<b>Tesla, Inc.</b> Service Bulletin		<b><i>Firmware Update for Traffic Aware Cruise Control (TACC)</i></b>	
<b>SB-21-00-002</b> June 26, 2021			
<b>Classification</b>		<b>Section/Group</b>	<b>Mobile Service</b>
Recall Bulletin		00 - Inspection & Service	Can Perform (where permitted)
<b>Model Year</b>	<b>Model</b>	<b>Country/Region</b>	<b>Version</b>
2019 - 2021	Model 3, Model Y	China	All
<small>The model(s) and model year(s) listed are a general approximation of the affected VIN list. Refer to the VIN/Bulletin Tracker or Customer/Vehicle profile to determine applicability of this bulletin for a particular vehicle.</small>

Figure 1

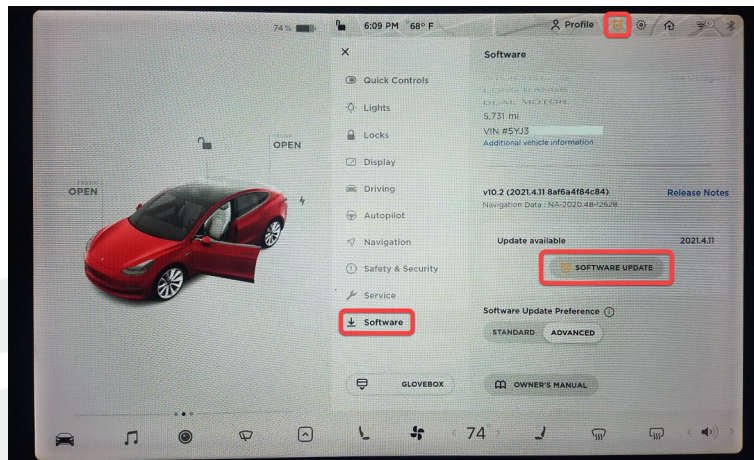
1. On the vehicle touchscreen, touch **Controls** (vehicle icon) > **Software**, and scroll down to display the vehicle firmware version. If firmware version is 2021.4.18.5, discontinue this procedure. Otherwise, continue to next step.
2. Select the clock in the center display, or touch **SOFTWARE UPDATE** (Figure 1).

Figure 2

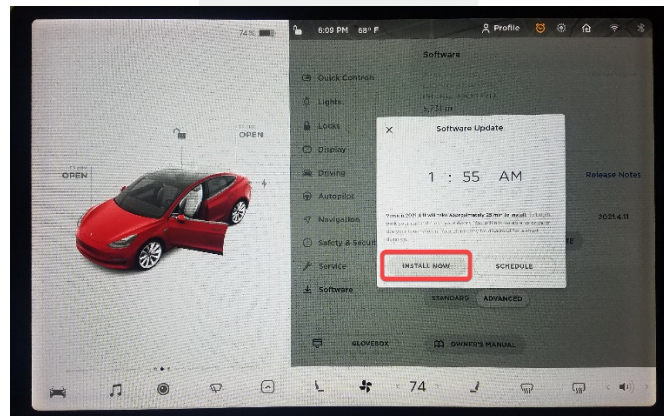
3. In **Software Update** window, touch **INSTALL NOW** to start the update (Figure 2).
